TENNESSEE VALLEY AUTHORITY BROWNS FERRY NUCLEAR PLANT (BFN) UNITS 1, 2, AND 3

PROPOSED TECHNICAL SPECIFICATION (TS) CHANGE TS-386 MARKED PAGES

PROPOSED TECHNICAL SPECIFICATION (TS) CHANGE TS-386 REVISED PAGES

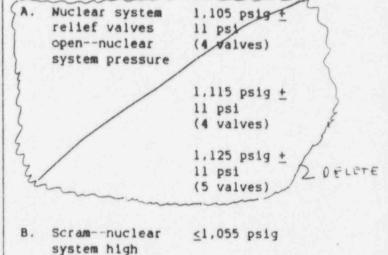
1 A.	Verify the safety funct	tion lift	settings of
1	the required S/RVs are setpoint as follows:	within ±	of the
-			three percent

Number of S/RVs	Setpoint (psig)	Three per	C C/III
4	1105		
4	1115		
5	1125		
Following testing, within t 18 0 one	, lift setting percent.	gs shall	be

The limiting safety system settings shall be as specified below: DINSERT Limiting Safety Protective Action System Setting

A. Verify the safety function lift settings of the required S/RVs are within <u>±</u> three percent of the setpoint as follows:

Number of S/RVs	Setpoint (psig)		
4	1105		
4	1115		
5	1125

Following testing, lift settings shall be within one percent.

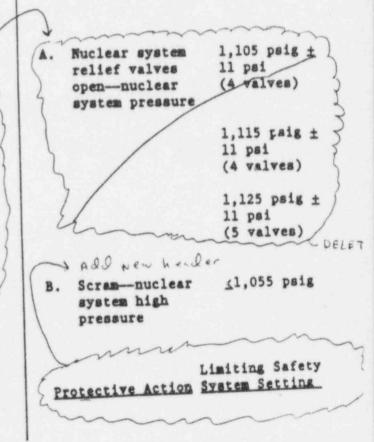
A. Verify the safety function lift settings of the required S/RVs are within ± 2% of the setpoint as follows:

ber of /RVs	Setpoint (psig)	11100	
4	1105		
4	1115		
5	1125

Following testing, lift settings shall be within $\pm 14 \not = 0^{10}$ percent.

A. Verify the safety function lift settings of the required S/RVs are within ± three percent of the setpoint as follows:

Number of	Setpoint		
S/RVs	(psig)		
4	1105		
4	1115		
5	1125

Following testing, lift settings shall be within one percent.
